Maryland Sand, Gravel, and Toluene (MSGS) Site Comments on
Chemical Results in the Phase II Report

Review of Maryland Sand and Gravel Site

SUBJECT: REVIEW OF MARYLAND, SAND, GRAVEL, AND STONE PHASE II REPORT

GENERAL COMMENTS ON THE MARYLAND SAND, GRAVEL, AND STONE SITE

FIGURE 51
LOCATION OF MONITORING
WELLS AND
RESIDENTIAL WELLS SAMPLED
NEAR THE SITE

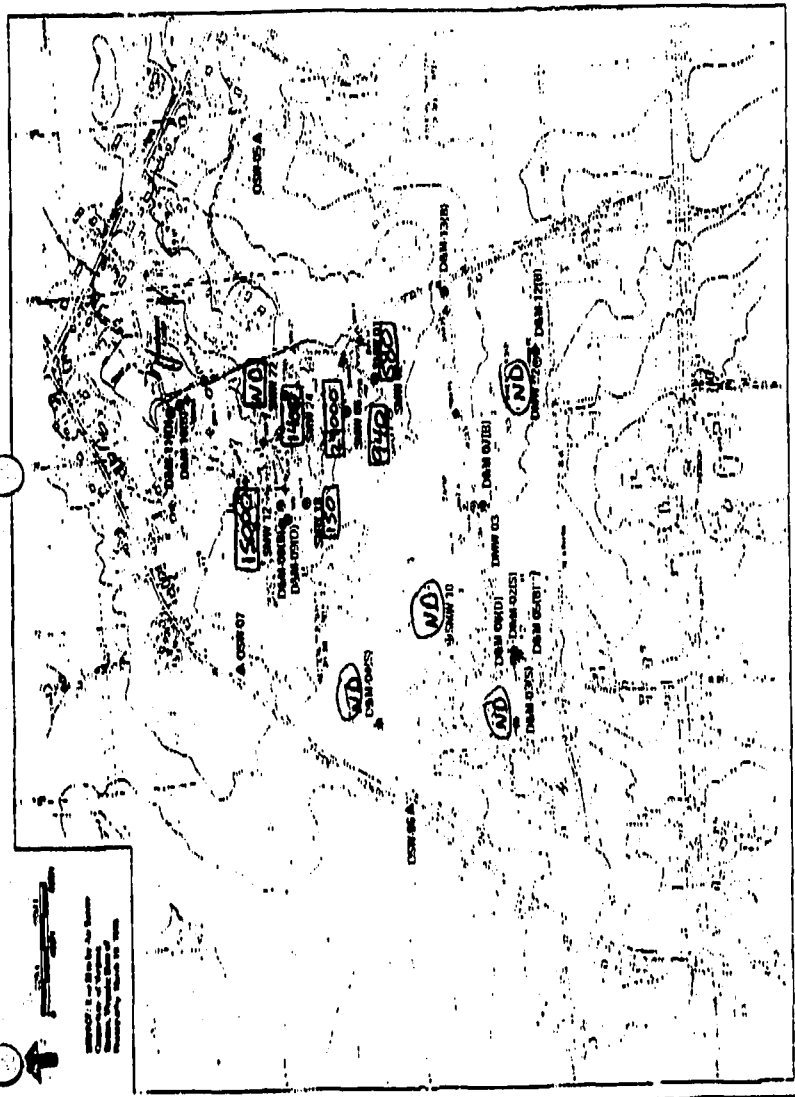
(1) The presence of toluene in 10 of the 11 Lower Sand and Bedrock (deeper aquifers) monitoring wells suggests that vertical migration is occurring between the contaminated Upper Sand aquifer and the deeper aquifers. Toluene is one of the volatile organic compounds (VOCs) detected in the Upper Sand monitoring wells that have been drilled near the Eastern Excavated Area disposal ponds. Its presence in the deeper aquifers contradicts the statement in the Phase II Report (p. 5-14) that the ground water elsewhere on the site is "essentially clean". The toluene concentrations in the Upper Sand range from 150 to 29,000 mg/L, and the concentrations in the deeper aquifers range from 6 to 120 ug/L.

1. Why is toluene the only VOC detected in the deeper aquifers (except for methylene chloride and acetone, which are probable lab contaminants)?
2. How do you reconcile the presence of toluene in the deeper wells with the extremely long travel times calculated from the slug test hydraulic conductivities?
3. Why is toluene present in the Upper Sand and deeper aquifers, but not the Middle Sand?

A large number of VOCs were detected in the Upper Sand wells near the disposal ponds (for example, 21 VOCs were detected in the sample from well SMW-01), yet toluene is generally the only VOC detected in the deeper aquifers. One possible explanation is that toluene is a widespread contaminant in the area and is not necessarily related only to the MSGS site. This explanation, however, is not well supported, because toluene was not detected in the deeper aquifer, off-site wells. Another possibility is that toluene was first at the site and has had the time to migrate vertically to the deeper aquifers and horizontally to the downgradient wells, and that the other contaminants in the Upper Sand wells were dumped at a later time. If only toluene was not dumped first and if the disposal ponds are the source of the toluene, then several of the other VOCs with similar solubility and partition coefficients should also be present in the downgradient wells. It would be interesting to know if toluene was detected in the off-site, downgradient wells (W-1,2,3) sampled during Phase I.

If the disposal ponds are the source of the toluene, then the calculated travel times presented in Table 5-12 appear to be too long. Six of the deeper aquifer

wells in which toluene was detected are near the southern boundary of MSGS, downgradient of the disposal ponds. The presence of toluene in these wells would require travel times similar to those calculated for the fractured bedrock in well D&M-07 (4.8 years from Pond 3 to D&M-07). If the other calculated travel times are correct, then there must be another source or migration pathway for the toluene.

The migration pathway for the toluene is also uncertain, because toluene has not been detected in any of the Middle Sand wells. Therefore, the suggested migration pathway from the contaminated Upper Sands to the deeper aquifer via surface seeps, recharge of the Middle Sands, and leakage through gaps in the confining units is not probable.

Figure 1
SOURCE: Data from the Air Survey
Commission of Virginia,
Pamplin, Virginia, Date of 1988.
The Commission, 1988.

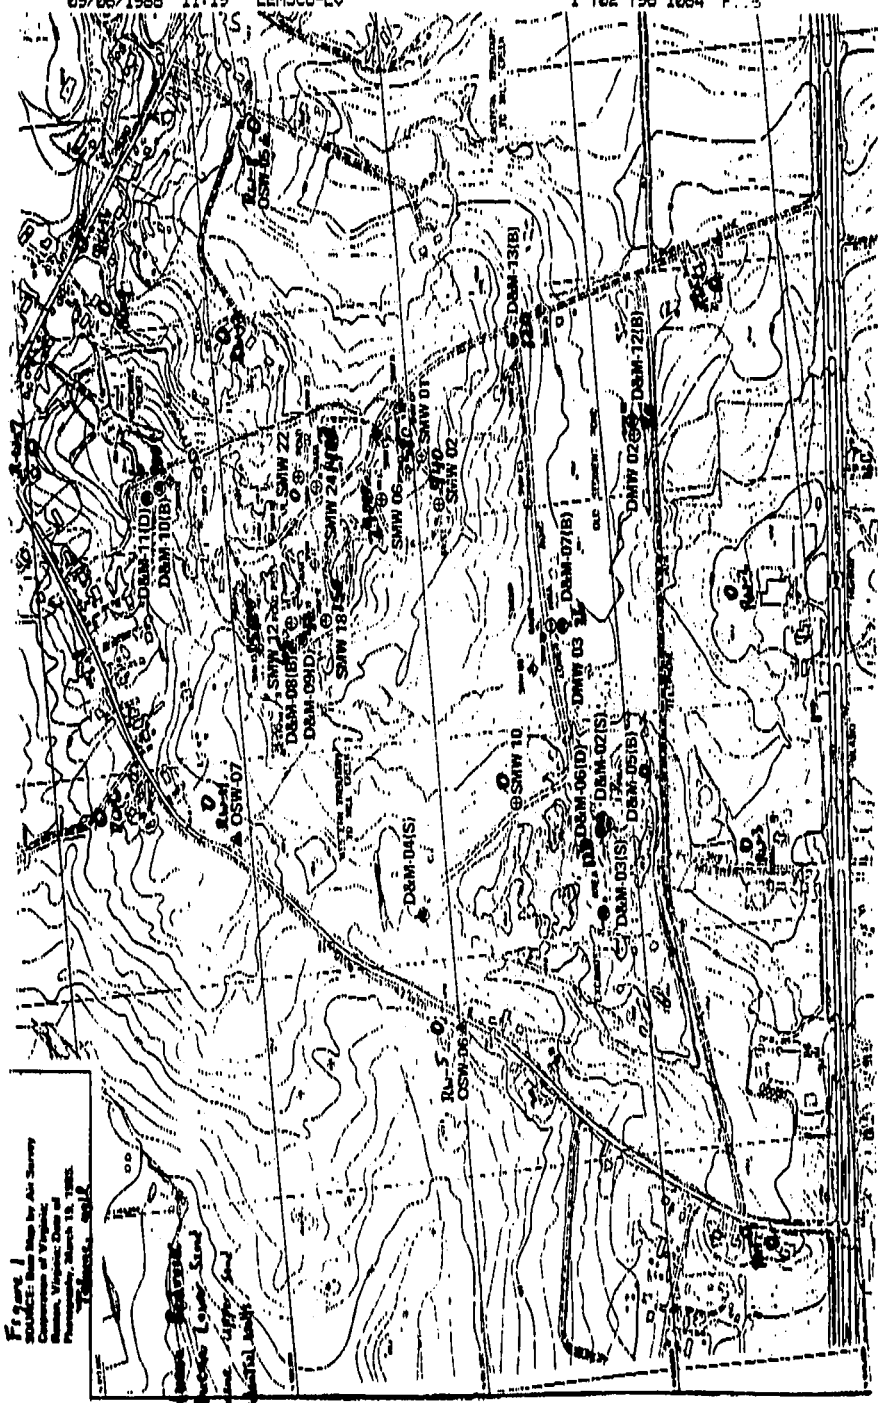
- P5.7 ¶ 4, Line 4: If silt/clay layer is absent from D&M-10, why is it indicated as being present in Figure 5-11?
- P5-10: According to Figure 5.1, wells SMW-12 and SMW-18 are near Pond 03 and wells SMW-22 and SMW-24 are near Pond 02. Text is incorrect.
